Issues SEARs including supplementary SEARS for the Modified Project

BDAR and BAM-C

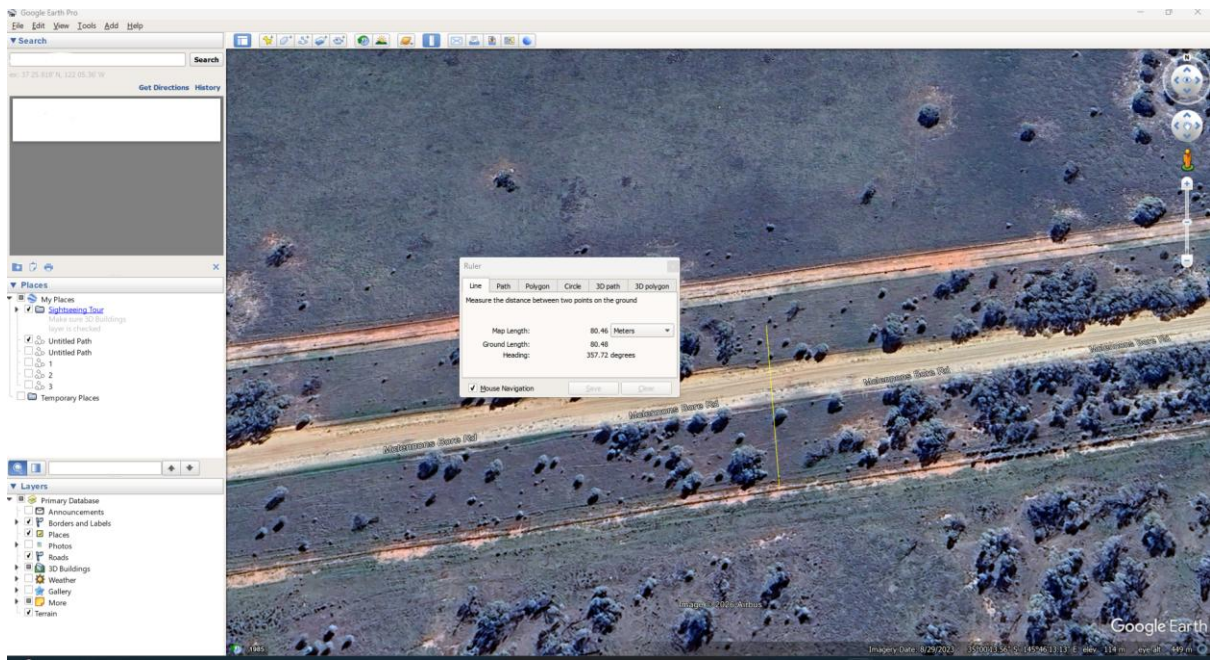
- The 50 m x 80 m is excessive and would literally land in the middle of McLennons Bore Road. As shown in the image below.

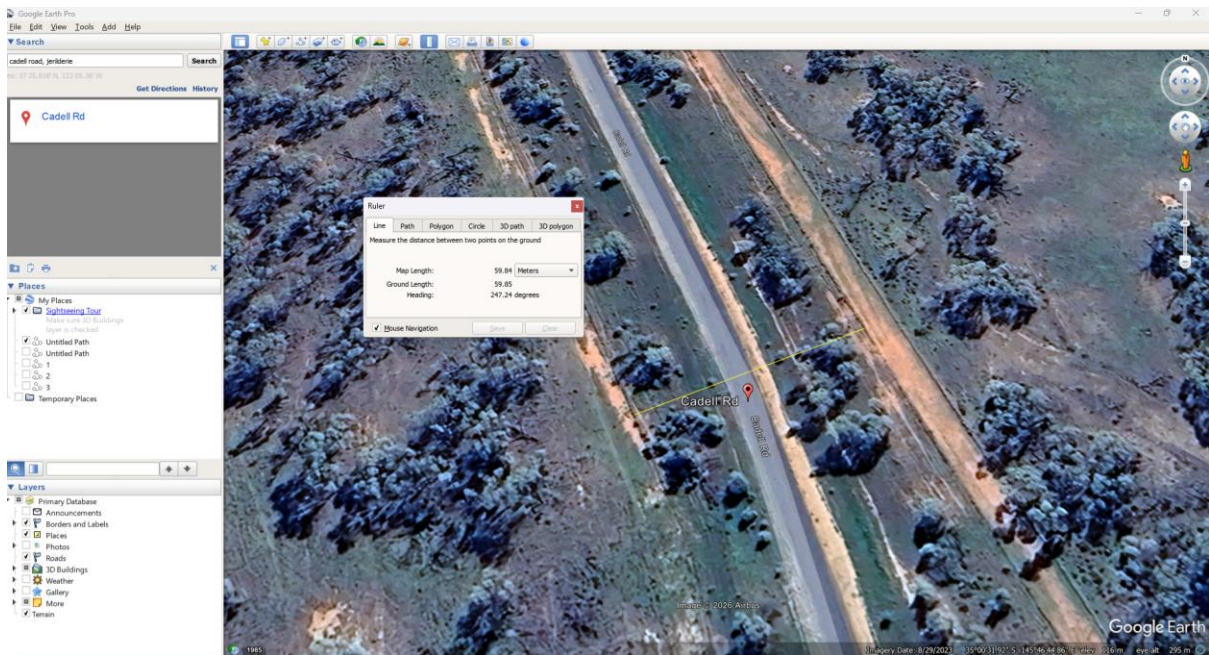
- Cadell Road would not accommodate these transmission lines as the road corridor is at a maximum of 65 m. The maximum width from road edge to the boundary fence is 23 m
